**TrustPower Limited McKays Creek Kaniere Forks
Reconsenting Project**

Joint s92 Response

West Coast Regional Council Item 1 (a-c)

Figure 1. Distribution of Lake Kaniere daily level change (m).

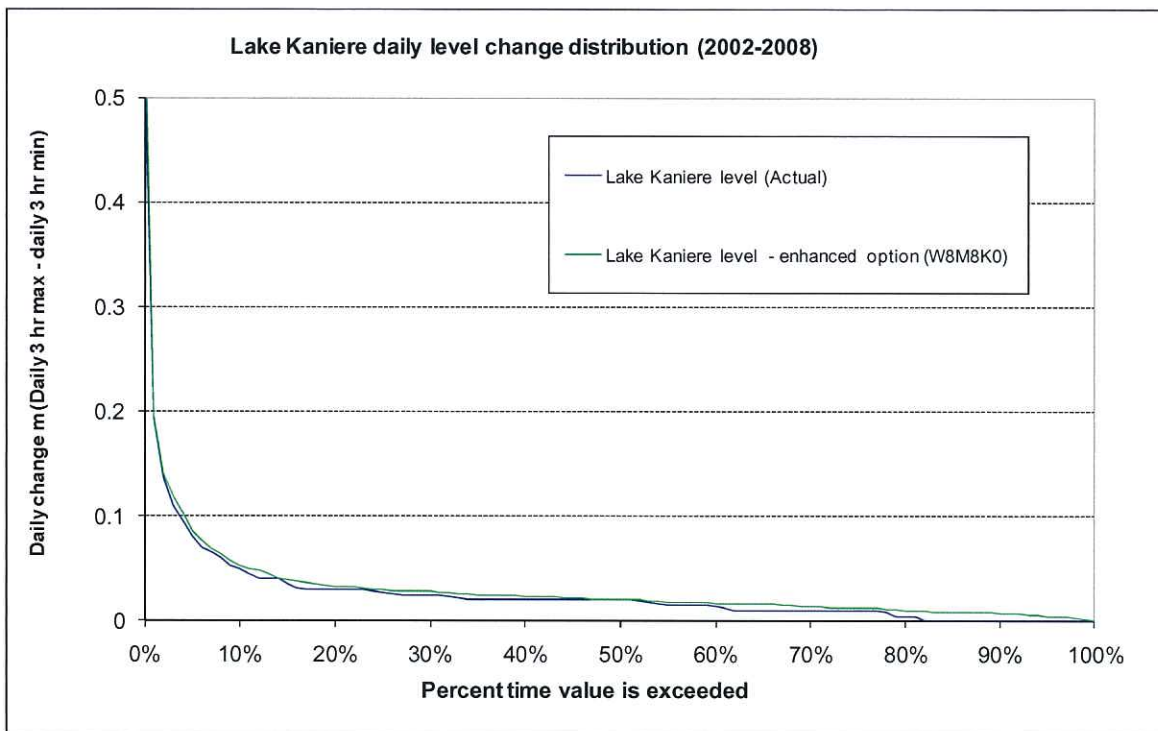
2(a) Please detail how quickly lake levels are likely to rise and fall and any potential effects as a result and mitigation proposed.

As stated in the AEE report "Kaniere Forks and McKays Creek Power Schemes Re-consenting: Hydrological Study (19 November 2010) section 6.2.2 page 32 and Figure 2.4, the distribution of the change between the daily 3-hourly maximum and 3-hourly minimum level is presented in Figure 1. As expected due to the relatively large volume of the lake (compared to outflows), that even with no inflows to the lake and a maximum outflow of 8 m³/s, a maximum daily drawdown of less than 0.05m would be achieved. The rate of change that would result from the additional 2m³/s abstraction would be proportionally less than 0.15m per day. The higher daily level changes are associated with level increases due to rainfall events. The systems used to measure the Lake Kaniere level have a 0.01m dead-band, hence the apparent 'steps' in the actual data in Figure 1.

Currently the maximum managed outflow from Lake Kaniere is around 6 m³/s (1 m³/s for Kaniere Forks station and up to 5 m³/s for McKays Creek station). This maximum will increase up to 8 m³/s for Wards plus the Kaniere River minimum flow requirement. All up a 2 m³/s to 3 m³/s increase in lake outflows is equivalent to an increase in the daily lake drawdown of less than 0.02m.

Median daily level change for actual and enhanced is 0.02m, with 95% of these daily level changes for both below 0.10m. The largest level changes measured or modelled was around 0.50m and occurred on 17 February 2005 due to a daily inflow flood to the lake of about 100 m³/s.

Thus there will be a slight increase in maximum lake draw-down, but generally the range of level changes will remain within the limits as previously observed for the lake.
